Addendum No. 4

Date: April 15, 2013
To: Contractors
From: Matthias Mueller – Program Director
Reference: Bachelor Enlisted Quarters Facility
Utah National Guard – Camp Williams, Utah
DFCM Project No. 10281480

ADDENDUM FOUR

BACHELORS ENLISTED QUARTERS FACILITY

SERVICE BLDG FIRST LEVEL PLAN, CEILING & ROOF

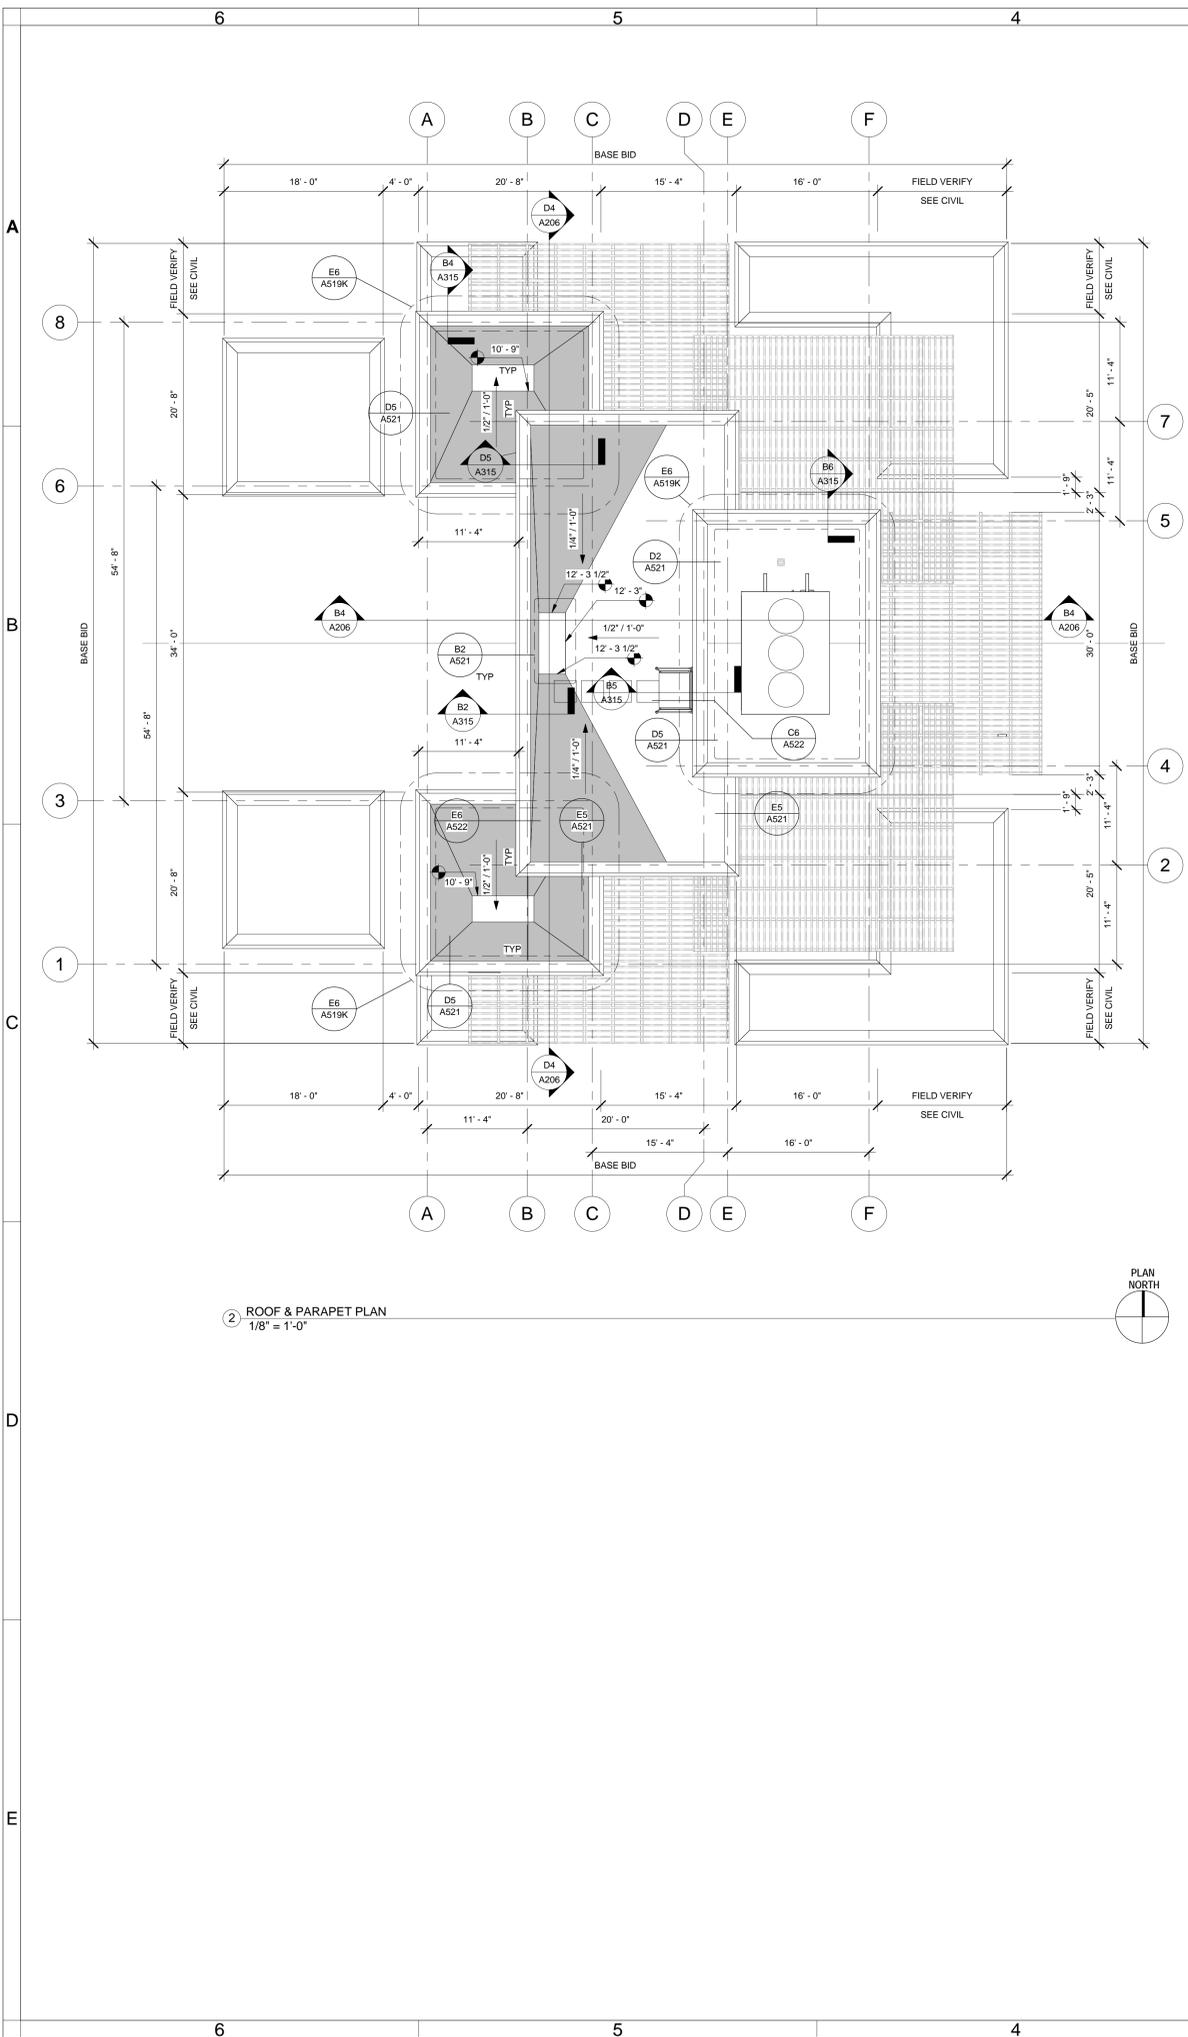
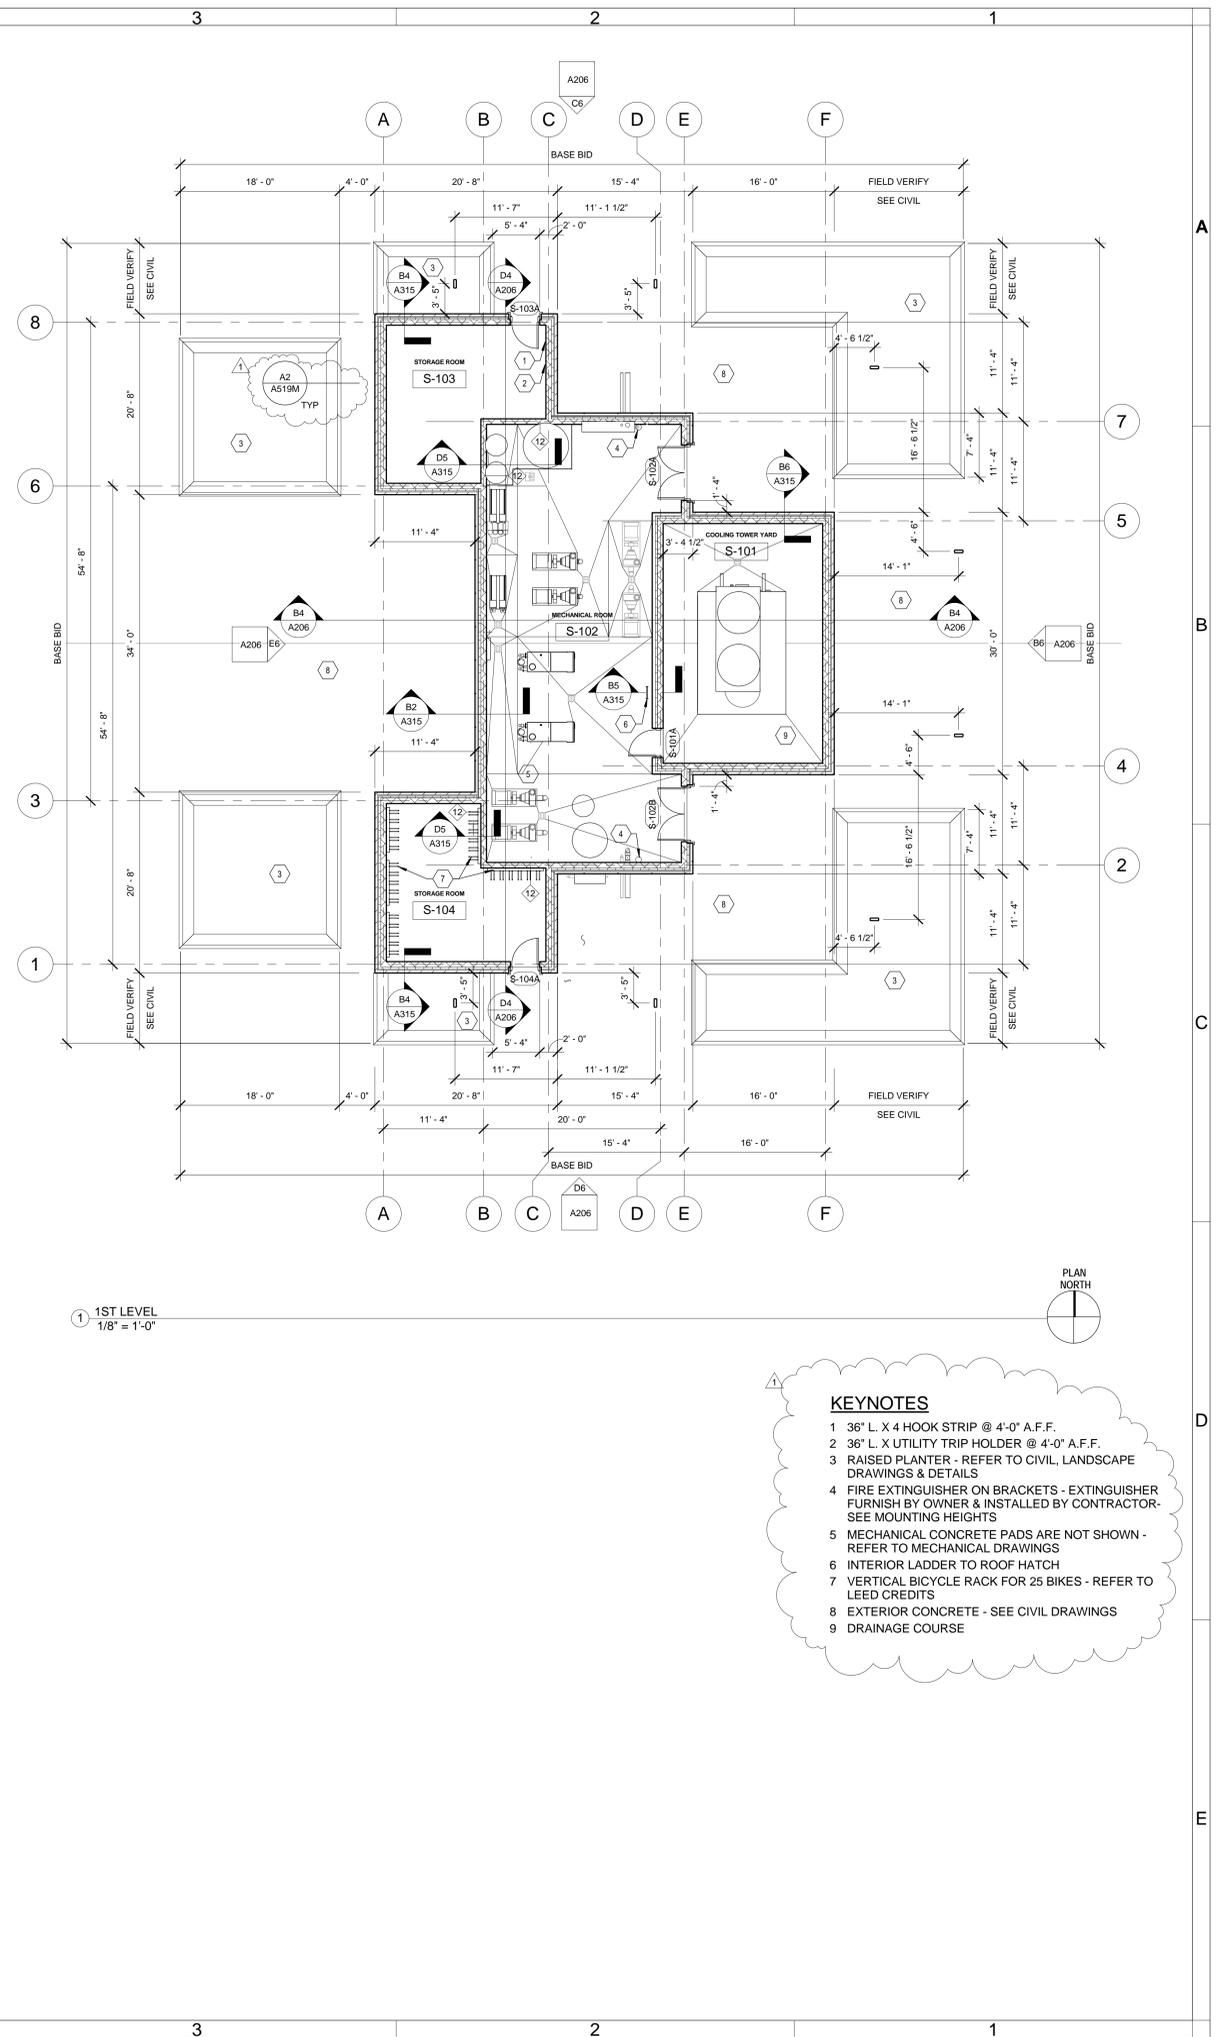
- 4.A01 Sheets A101A, A101B, A102A, A102B, A103A, A103B: Modify Key Note 14 to read: WALL WITH CONSTRUCTION CAPABLE OF RESISTING THE PASSAGE OF SMOKE – SEE CODE PLAN.
- 4.A02 Replace Sheet A104 with the enclosed updated Sheet A104. The followings are the updates made:
- Added the description of the keynotes called by the drawings.

- Added planter's typical section detail callout.
- 4.A03 Add to General Notes of sheet A111 the general note 17 to read:
CONTINUOUS ROOF INSULATION MUST PROVIDE AN R-VALUE OF 38
MINIMUM.

E5 WINDOW ALUM W/ PRECAST JAMB, HEADER & SILL DETAIL (EXT)
 SCALE: 3" = 1'-0"

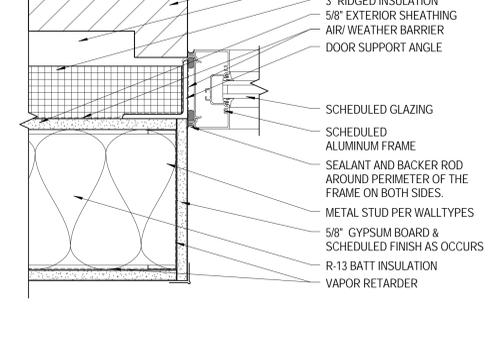
4.QA15 Drawings: A504 detail E5 calls for the precaster to support the sills and headers. These sills and headers will be made solid for cost savings. The support of the sills and headers should be by the masons that would install the sills and headers in conjunction with the window and door jambs and masonry at the same time.

4.QA25 Detail E5/A503&A504 show precast sills and lintels, these will be made solid not hollowed out. How is the precast to attach to the masonry through the insulation?

- Detail E5/A504 is showing the construction elements for the jamb, sill and head conditions of some of the punched windows, but it is not assigning who does and who does not do any of the work. Once more, the architectural/engineering team will NOT dictate means and

- Refer to detail C1/A513 showing details, sizes and notes for precast concrete sills, jambs and headers. The details notes consider and allow the pieces to be solid. The architect will NOT dictate on this decision. It is a responsibility of the successful bidder to present the final structural design calculations in compliance with all the requirements stated within the construction documents to fabricate and install the precast concrete elements inclusive of the required support to attach such elements to the provided structure. The precast concrete structural design, requirements and installation shall be in compliance with stated under the construction documents and specifications for precast concrete.

E4 ADD04-A01
 1 1/2" = 1'-0"

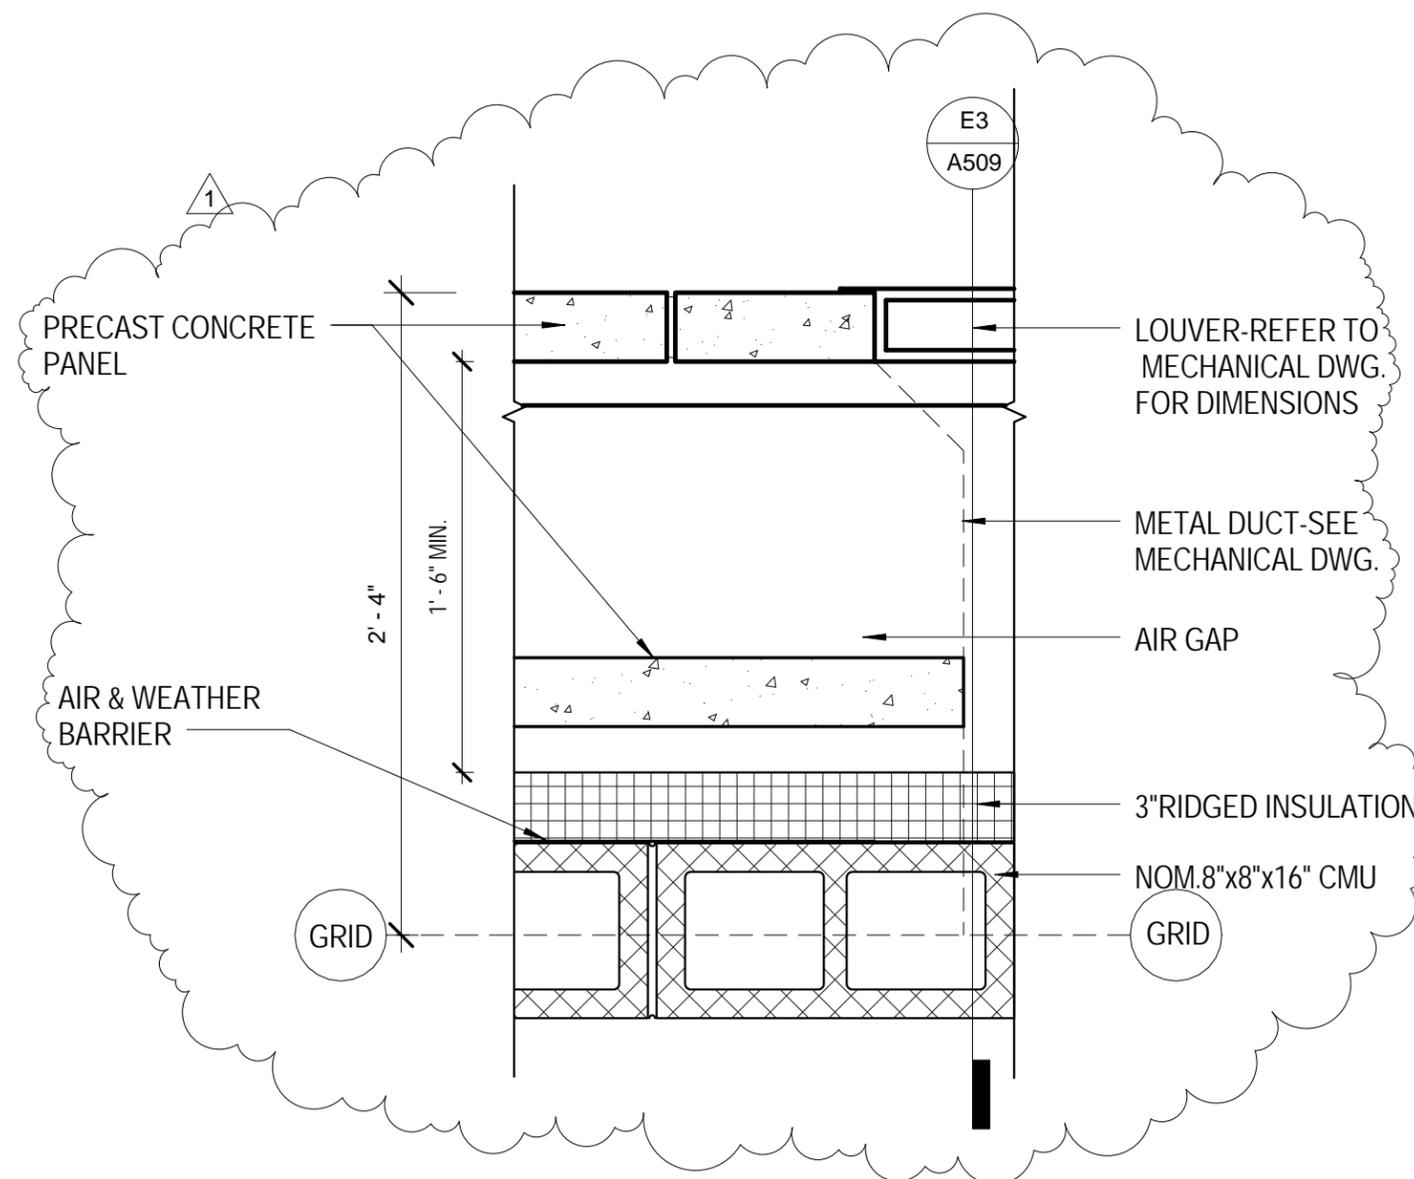
- 4.A04 Replace detail E4/A509 with the enclosed updated detail AD4-A01 drawing.
- 4.A05 Replace detail E3/A509 with the enclosed updated detail AD4-A02 drawing.

DRAWN BY: **CO CS CR** CHECKED BY: **CR MM**
 PROJECT NO: **11007** DRAWING NO: **A515**
 DATE: **02/15/2013**

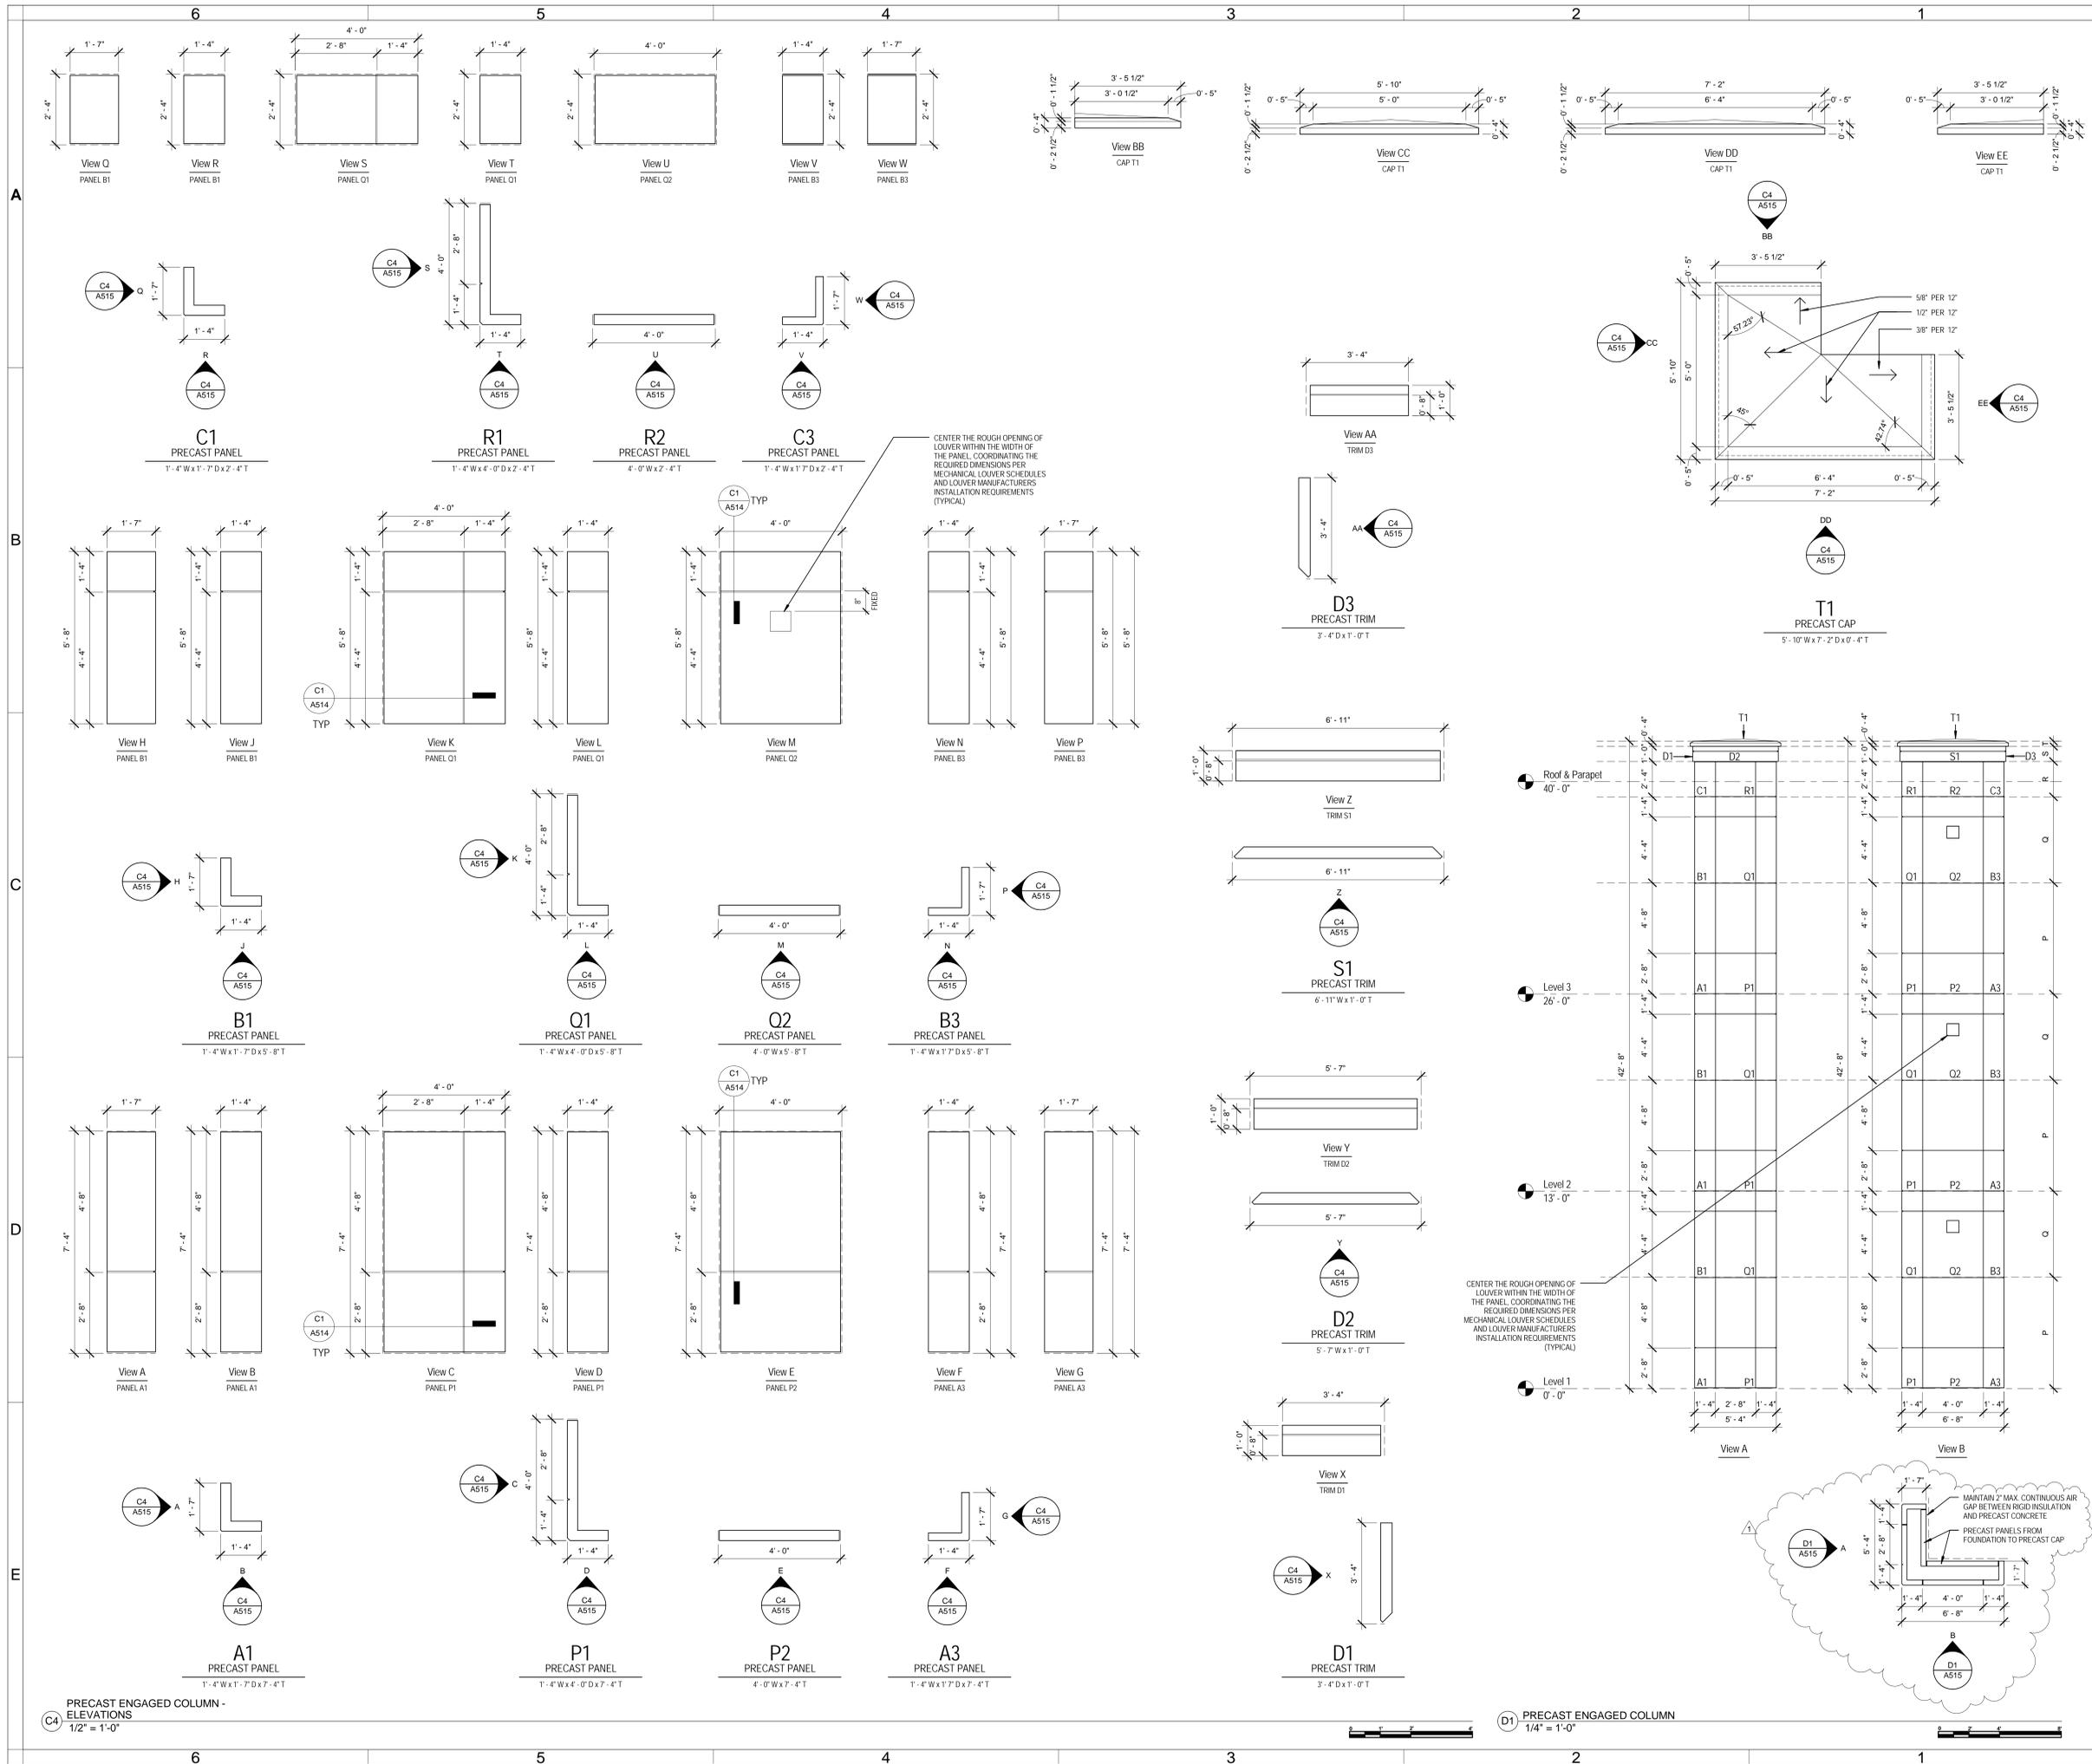
- Modified precast engaged column floor plan.
 - Added notes to precast engaged column floor plan.
- 4.A08 Replace Sheet A515 with the enclosed updated Sheet A515. The followings
are the updates made:

- Modified precast engaged column floor plan.
 - Added notes to precast engaged column floor plan.
- 4.A09 Add detail A2 to sheet A519M per the attached AD4-A03 drawing.
